**Amendments to:
State Air Quality Control Plan**

**Volume III: Appendix III.K.6
Best Available Retrofit Technology (BART) Documentation**

DEC GVEA BART Final Determination Report 2-5-10 (revised 6-1-10)

DEC GVEA BART Final RTC 2-5-10

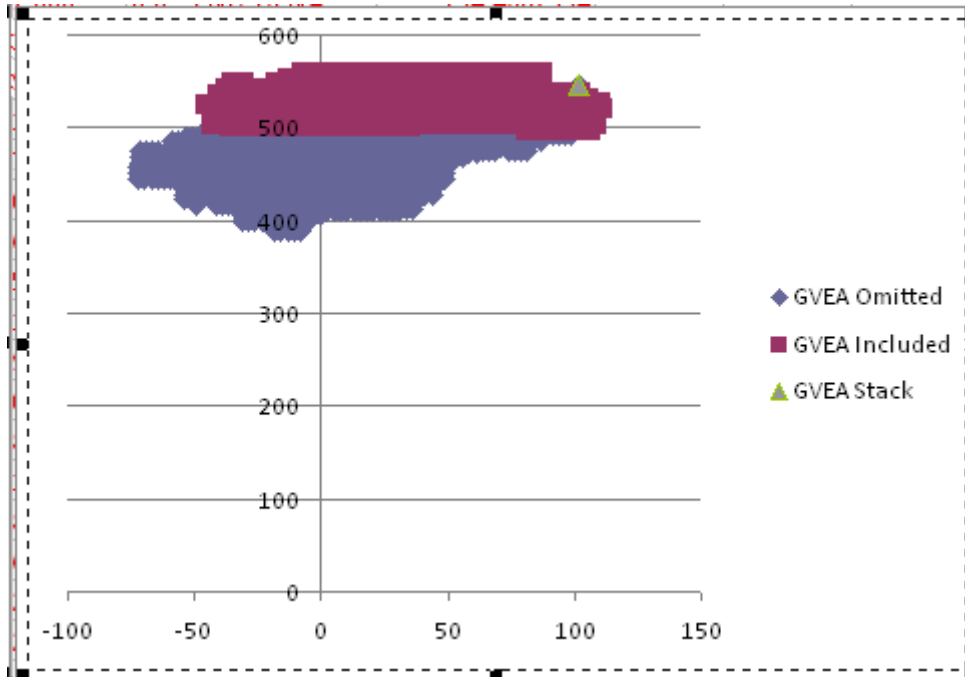
The maximum modeled visibility impact associated with Auxiliary #1 Boiler using corrected maximum NO_x and SO₂ emission rates continues to show this emission unit is not predicted to cause or contribute to visibility impairment at DNP.

It is noted that the Auxiliary #1 Boiler revised maximum visibility impact presented above occurred at a location included in GVEA’s visibility modeling analysis. Therefore, the revised

maximum impact is attributable solely to the corrected unit NO_x and SO₂ emission rates. The 776 previously omitted receptors are relatively distant from the Healy Power Station, and the 591 receptors initially modeled by GVEA are located in relatively close proximity to the plant and remain the dominant receptors in this analysis. The figure below shows the locations of these groups of receptors relative to the Healy Power Station.

While this analysis has focused on GVEA's Auxiliary #1 Boiler, GVEA's omission of the 776 receptors may affect their prior visibility modeling for Healy Unit 1. GVEA omitted the same 776 receptors from the Healy Unit 1 Calpost input files. As such, Enviroplan conducted revised Calpuff/Calpost modeling of Healy Unit 1. The analysis was limited to the GVEA Healy 1 baseline configuration (i.e., maximum daily NO_x, SO₂ and PM emission rates) scenario. Enviroplan corrected GVEA's Calpost **NDRECP** option to include all 1367 receptors; and no other changes were made to GVEA modeling files.
